Road Safety Audit

Tripoli Way Extension

Detailed Design RSA

Final RSA Report

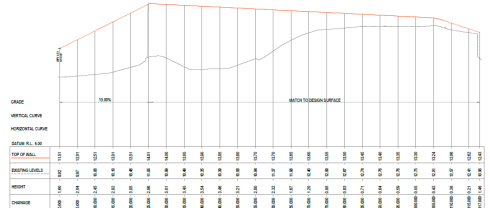
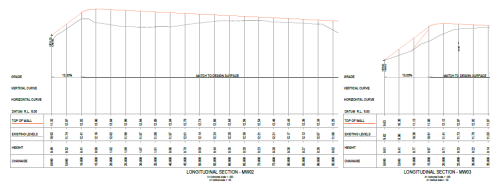
CAR No	Location Category	Description of Risk to Road Safety	Photographs/ Plans / Drawing No	Risk Assessment	Client Response
1.	Tripoli Way CH490 to CH555 Pedestrian infrastructure and cyclist infrastructure	There is a lack of barriers / fencing on top of the proposed retaining walls to protect cyclists and / or pedestrians on the shared path from going over the edge of the retaining walls. This may result in errant pedestrians and / or cyclists falling over the retaining walls, resulting in injury.	Refer Sheet No. 870 	Likeli-hood	Pedestrian/cycle handrail (Monowills) has now been incorporated into the top of the retaining wall to protect errant pedestrians and / or cyclist from falling over the retaining walls. The incorporation of the handrail will result in a lower likely hood of an errant cyclist and/or pedestrian falling over the retaining wall. Please refer to 9470-11-551, 9470-11-0870 and the below screenshots.

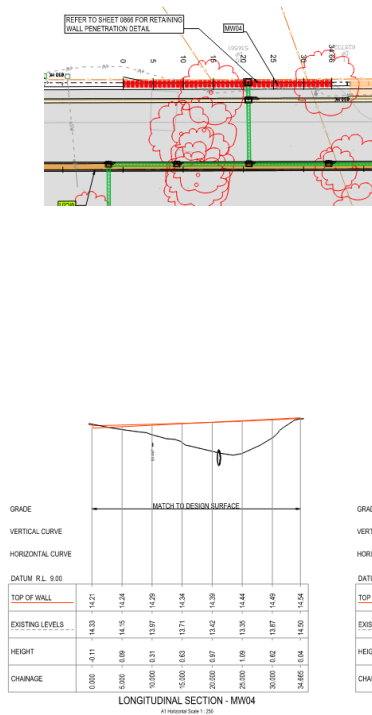
CAR No	Location Category	Description of Risk to Road Safety	Photographs/ Plans / Drawing No	Risk Assessment	Client Response
2.	Tripoli Way CH530 Safety barriers	There are no barrier connections, including terminals on the eastern side of the bridge structure. If terminals are proposed to be connected directly to the bridge structure, this may not protect occupants of vehicles from hazards (i.e. drop over retaining walls). This may lead to serious injury to occupants of vehicles.	Refer sheet No. 102  Refer Sheet No. S100 	Likeli-hood	Type RBO are on the guard rail connection to the bridge and ET-SS terminal at the point of need on the eastern side of the bridge. A Crash barrier system and end terminals have now been provided on the eastern side of the bridge. The incorporation of the barrier system will result in a lower likely-hood of an errant vehicle falling over the retaining wall. Please refer to 9470-11-551, 9470-S100 and the below screenshots.

CAR No	Location Category	Description of Risk to Road Safety	Photographs/ Plans / Drawing No	Risk Assessment	Client Response
			Refer sheet No. 552

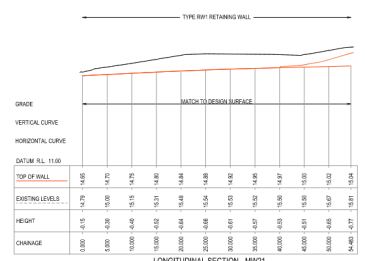
CAR No	Location Category	Description of Risk to Road Safety	Photographs/ Plans / Drawing No	Risk Assessment	Client Response
3.	Tripoli Way CH635 to CH685 Auxiliary lanes	The proposed merge and diverge tapers on Tripoli Way, west of Moles Street appear short to suit a 70km/h design speed. This may lead to drivers being required to merge at a lateral rate greater than 1.0 m/sec which may increase the risk of vehicle crashes.	Refer sheet No. 103 	Likeli-hood	The merge and diverge tapers have been updated to allow for a 1.0 m/sec lateral shift. The resultant diverge taper is now 70m in length which is compliant with Austroads requirements. The resultant merge taper is now 115m in length which is compliant with Austroads requirements. With the increased length of the merge, additional signage for the merge and the available extra run off a lower likely-hood is expected. Please refer to 9470-11-103 and the below screenshot.

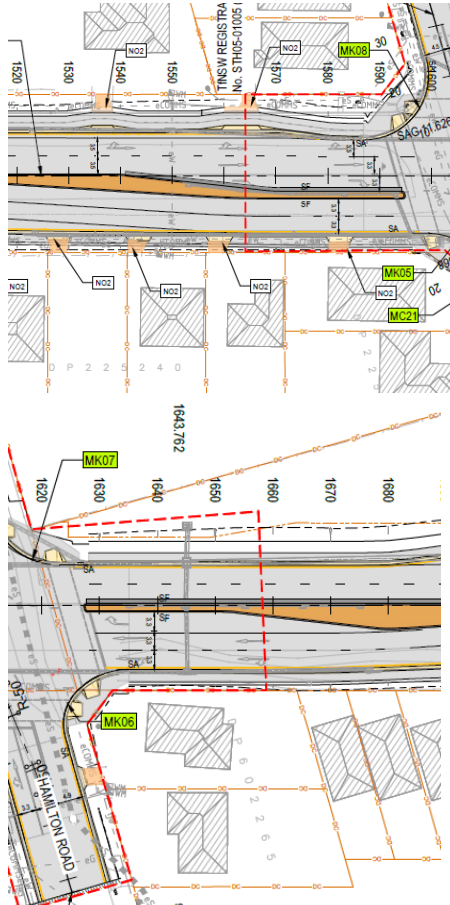
CAR No	Location Category	Description of Risk to Road Safety	Photographs/ Plans / Drawing No	Risk Assessment	Client Response
4.	Tripoli Way Various locations Pedestrian infrastructure and cyclist infrastructure	There is a lack of pedestrian and cyclist protection at the top of retaining walls located along the shared path (i.e. pedestrian fencing). This may result in errant pedestrians and / or cyclists falling over the retaining walls, resulting in injury.	Refer sheet No. 871   Refer sheet No. 872  	Likeli-hood	Pedestrian/cycle handrail (Monowills) has now been incorporated into the top of the retaining wall to protect errant pedestrians and / or cyclist from falling over the retaining walls. The incorporation of the handrail will result in a lower likely hood of an errant cyclist and/or pedestrian falling over the retaining wall. Please refer to 9470-11-0871, 9470-11-0872, and the below screenshots.

CAR No	Location Category	Description of Risk to Road Safety	Photographs/ Plans / Drawing No	Risk Assessment	Client Response
			Refer sheet No. 873

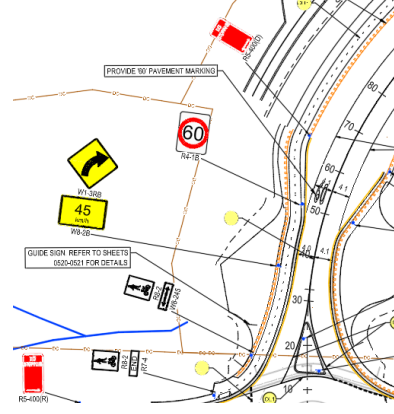
CAR No	Location Category	Description of Risk to Road Safety	Photographs/ Plans / Drawing No	Risk Assessment	Client Response
					 PLAN SCALE 1:100 @ A1  LONGITUDINAL SECTION - MW21

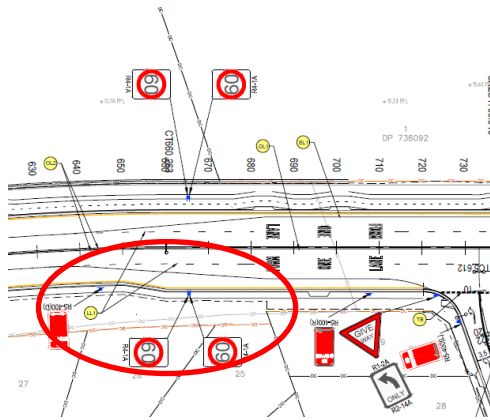
CAR No	Location Category	Description of Risk to Road Safety	Photographs/ Plans / Drawing No	Risk Assessment	Client Response
5.	Terry Street CH100 to CH180 Roadside hazards	The roadside retaining wall southbound on Terry Street (Illawarra Highway) is only protected by kerb and gutter for vehicles. Errant vehicles which mount the kerb at these locations will be unable to recover before crashing over the retaining wall. This may lead to serious injury to occupants of a vehicle.	Refer sheet No. 874  	Likeli-hood	Removed from Indesco's design scope, this section is now under a Design and Construct scope which is being delivered by others.
				Unlikely	
				Severity	
				Serious	
				Risk Level	
				High

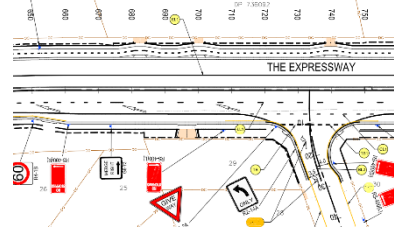
CAR No	Location Category	Description of Risk to Road Safety	Photographs/ Plans / Drawing No	Risk Assessment	Client Response
6.	Tripoli Way and Calderwood Road Miscellaneous	The proposed Calderwood Road travel lane arrangement in both directions is a combination through / right turn lane and dedicated left turn lane. The proposed phasing only allows movements for the through / right turn vehicles during D phase, in both directions. Through vehicles may become frustrated being stuck behind waiting right turn vehicles and use the left turn lane to go around. This may increase the risk of a through vehicle striking an oncoming left turning vehicle or opposing right turning vehicle. This may lead to vehicle crashes and result in injury to occupants of vehicles.	Refer TCS Plan "TCS_Tripoli Way_Calderwood Rd_R1.pdf" 	Likeli-hood	Straight and right turn lane is the required configuration for the traffic modelling. Changing to a right turn lane with a straight and left will lead to more queuing and additional frustrations. Due to the traffic model requirements it is proposed to leave the intersection as is.

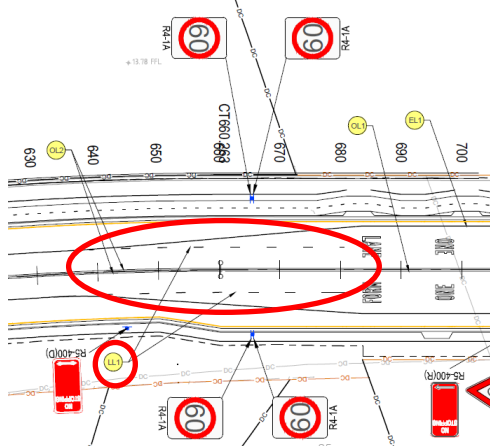
CAR No	Location Category	Description of Risk to Road Safety	Photographs/ Plans / Drawing No	Risk Assessment	Client Response
7.	Tripoli Way and Hamilton Road Intersections	The proposed right turn bays eastbound and westbound on Tripoli Way approaching Hamilton Road appear short to suit a vehicle to decelerate, stop and store within the right turn bay without impacting through vehicles on Tripoli Way. This may increase the risk of vehicle crashes (i.e. rear-end type crashes). This may lead to injury to occupants of vehicles.	Refer sheet No. 106 	Likeli-hood	Increased risk noted. Aux lanes added as original concept had no channelized turns. Initial Traffic modelling showed low volumes. Right turn bays are designed as a Short Right turn lane to accommodate a single turn vehicle per the traffic modelling.
				Rare	
				Severity	
				Moderate	
				Risk Level	
				Low

CAR No	Location Category	Description of Risk to Road Safety	Photographs/ Plans / Drawing No	Risk Assessment	Client Response
			Refer TCS Plan "TCS_Tripoli Way_Hamilton Rd_R1.pdf"

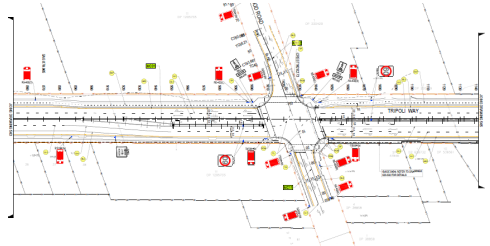
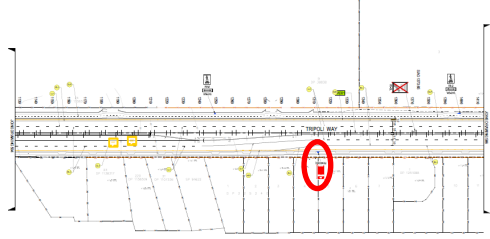
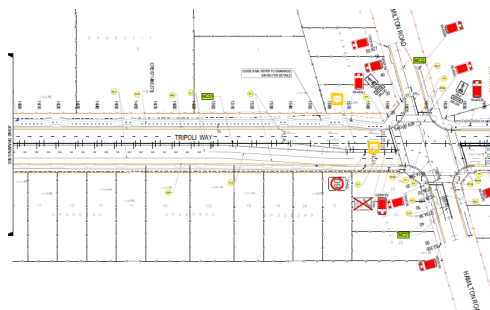
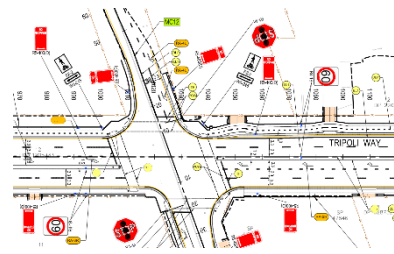
CAR No	Location Category	Description of Risk to Road Safety	Photographs/ Plans / Drawing No	Risk Assessment	Client Response
8.	Tripoli Way CH50 to CH70 Pedestrian infrastructure and cyclist infrastructure	Between CH50 and CH70 northbound on Tripoli Way, pedestrians and cyclists within the proposed shared path are not separated or protected from through vehicles. This is in particular in the future when there are two travel lanes at this location in each direction. This may increase the risk of errant vehicles to strike a pedestrian / cyclist at this location leading to serious injury to a pedestrian / cyclist.	Refer sheet No. 501 	Likeli-hood	Comment noted. Barrier between Road and shared path not a requirement under the standards. No kerb side parking allowed means buffer not required. Future connection if implemented will be signals and the path will be realigned. This is on the Northbound exit from the roundabout. It is expected that vehicles will not be diverging in this location due to the slow speed curve ahead and that traffic will be in a single lane past this location. The shared path is originally separated with the kerb.

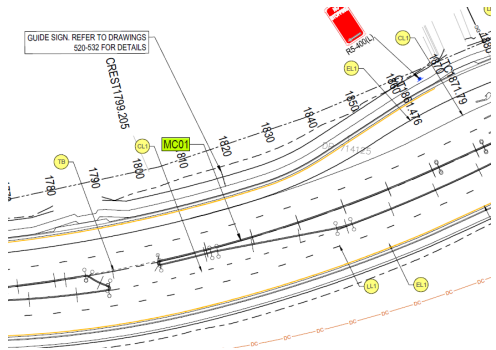
CAR No	Location Category	Description of Risk to Road Safety	Photographs/ Plans / Drawing No	Risk Assessment	Client Response
9.	Tripoli Way CH680 Traffic signage	There is a lack of traffic signage to advise drivers of the proposed merge at this location. This may create readability issues for drivers approaching the merge at this location. This may lead to late lane decisions and increase the risk of vehicle crashes (i.e. side swipe type crashes).	Refer sheet No. 503 	Likeli-hood	Signage revised with increase in merge length, complies with AS1742. Additional signage has been included to warn drivers of the merge ahead. There is sufficient runoff space in the form of a 4.5m shoulder beyond the merge that will enable vehicles to avoid the run off space. With the increased length of the merge, additional signage for the merge and the available extra run off a lower likely-hood is expected. Please refer to 9470-11-503 and the below screenshot for the additional signage employed.

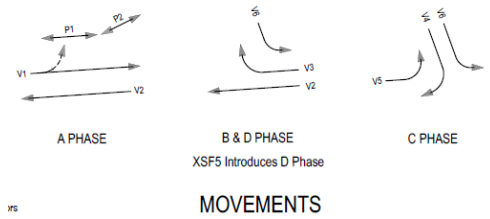
CAR No	Location Category	Description of Risk to Road Safety	Photographs/ Plans / Drawing No	Risk Assessment	Client Response
10.	Tripoli Way CH640 to CH680 Delineation	The proposed linemarking and signage plan at CH640 to CH680 in both directions at the merge and diverge shows LL1 linemarking. This may cause driver confusion and readability issues that this is a merge / diverge at this location. This may lead to late lane decisions and increase the risk of vehicle crashes (i.e. side swipe type crashes).	Refer Sheet No 503 	Likeli-hood	Merge length increased. The linemarking has been updated to include a LL1 line on the lead in to the merge then a CL1 line through the merge location. With the increased length of the merge, additional signage for the merge and the available extra run off a lower likely-hood is expected. Please refer to 9470-11-503 and the below screenshot.
				Unlikely	
				Severity

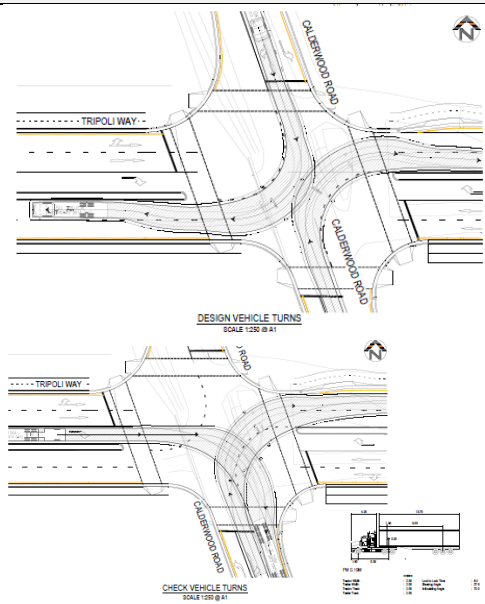
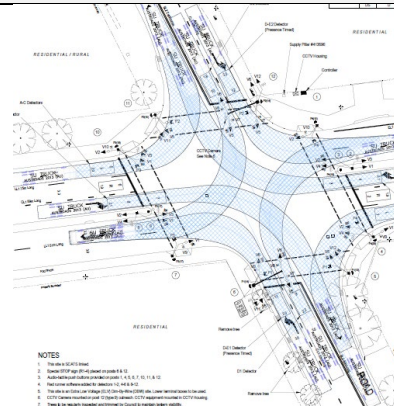
CAR No	Location Category	Description of Risk to Road Safety	Photographs/ Plans / Drawing No	Risk Assessment	Client Response
11.	Tripoli Way Various locations Traffic signs	Along Tripoli Way “No stopping” signage is shown at inconsistent and large gaps to accompany NS1 (clearway) linemarking. Over time if the NS1 linemarking is removed (i.e. due to road works or worn) this may create readability issues for drivers and increase the likelihood of drivers parking in unsafe locations. This may increase the risk of vehicle crashes.	Refer sheet No. 504  Refer sheet No. 505  Refer sheet No. 506 	Likeli-hood Unlikely Severity Minor Risk Level Low	“No stopping” signage has been updated to be a smaller maximum 75m intervals as per the relevant Australian standards (AS1472.13). As a result of the reduction in gaps it shall lower the likely-hood of a vehicle stopping at an area not designated for stopping. Additionally, NS1 line marking has been used to delineate the no stopping zones. Please refer to 9470-11-504, 9470-11-505 & 9470-11-506 and the below screenshots.

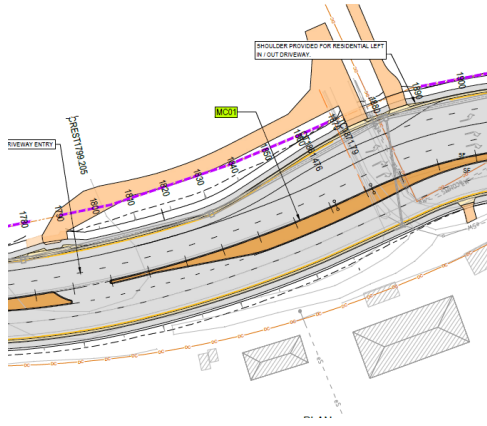
CAR No	Location Category	Description of Risk to Road Safety	Photographs/ Plans / Drawing No	Client Response
1.	Tripoli Way CH700 Delineation	There is a proposed "Form one lane" pavement message located on the diverge between two lanes. This may cause driver confusion and lead to drivers changing lanes back to Lane 2 in the middle of a change to Lane 1. This may increase the risk of vehicle crashes (i.e. side swipe type crashes).	Refer sheet No. 103 	The proposed line marking has been updated to include a LL1 line on the lead in to the merge then a CL1 line through the merge location. With the increased length of the merge, additional signage for the merge and the available extra run off a lower likely-hood is expected. Please refer to 9470-11-103 and the below screenshot.

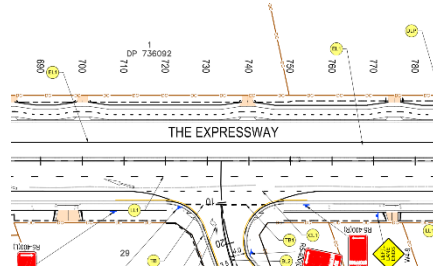
CAR No	Location Category	Description of Risk to Road Safety	Photographs/ Plans / Drawing No	Client Response
2.	Tripoli Way and Calderwood Road, Tripoli Way and Hamilton Road, And Tripoli Way and Terry Street (Illawarra Highway) Pedestrian infrastructure and cyclist infrastructure	The audit team observed within the Civil plans and TCS plans that the proposed kerb ramps are not full width kerb ramps at the proposed TCS intersections as per TfNSW specifications.	Refer sheet No. 104  Refer sheet No. 106 	Kerb ramps all 2.5m wide, as agreed with Client. Terry Street intersection is now removed from Indesco's design scope, this section is now under a Design and Construct scope which is being delivered by others..

CAR No	Location Category	Description of Risk to Road Safety	Photographs/ Plans / Drawing No	Client Response
			Refer sheet No. 108

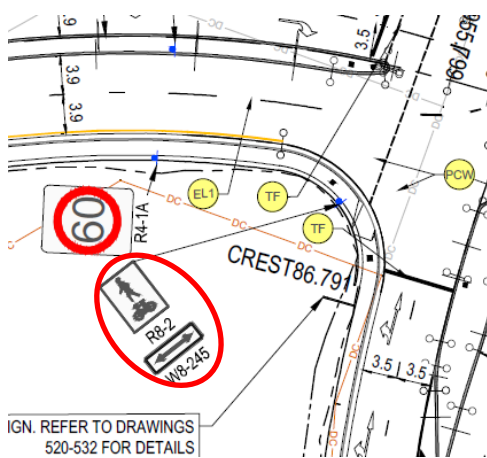
CAR No	Location Category	Description of Risk to Road Safety	Photographs/ Plans / Drawing No	Client Response
3.	Tripoli Way and Calderwood Road Road alignment and cross section	Proposed retaining wall details and verge details at the south-eastern corner of the intersection of Tripoli Way and Calderwood Road are not clear on the cross sections.	Refer Sheet No. 104  Refer Sheet No. 215 	The Cross sections through this section have been amended to show the retaining wall correctly. There was a slight issue within the modelling causing a redundant 'string' to be picked up during the creating of cross sections. Please refer to 9470-11-104 & 9470-11-215 and the below screenshots.

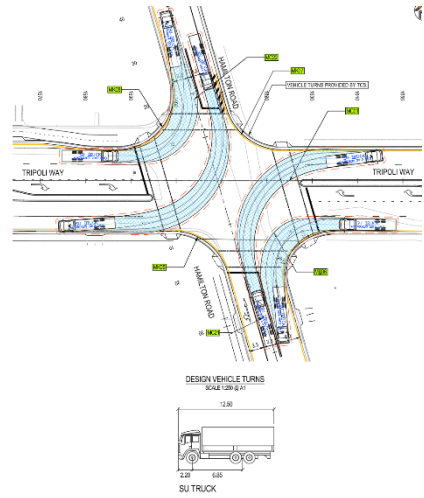
CAR No	Location Category	Description of Risk to Road Safety	Photographs/ Plans / Drawing No	Client Response
4.	Tripoli Way CH1790 Access impacts	It is unclear to the audit team whether heavy vehicles have been considered to the proposed access to Albion Park Landscaping Supplies. This includes storage within the right turn lane and the internal driveway geometry. This may lead to the Audit team not fully appreciating the site conditions for all road users along and on the approaches to the proposed road works at this location.	Refer Sheet No.107 	Removed from Indesco's design scope, this section is now under a Design and Construct scope which is being delivered by others.

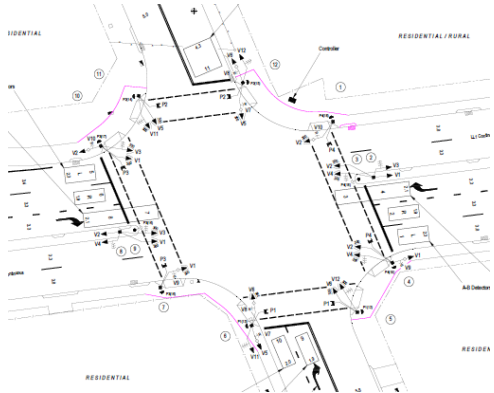
CAR No	Location Category	Description of Risk to Road Safety	Photographs/ Plans / Drawing No	Client Response
5.	Tripoli Way and Moles Street CH710 to CH760 Delineation	The linemarking and signage plans note a CL1 line which is missing from all plans.	Refer Sheet No. 503 	The CL1 line marking has been placed back into the plans. The intention is the CL1 line will go through the intersection. Please refer to 9470-11-503 and the screenshot below.
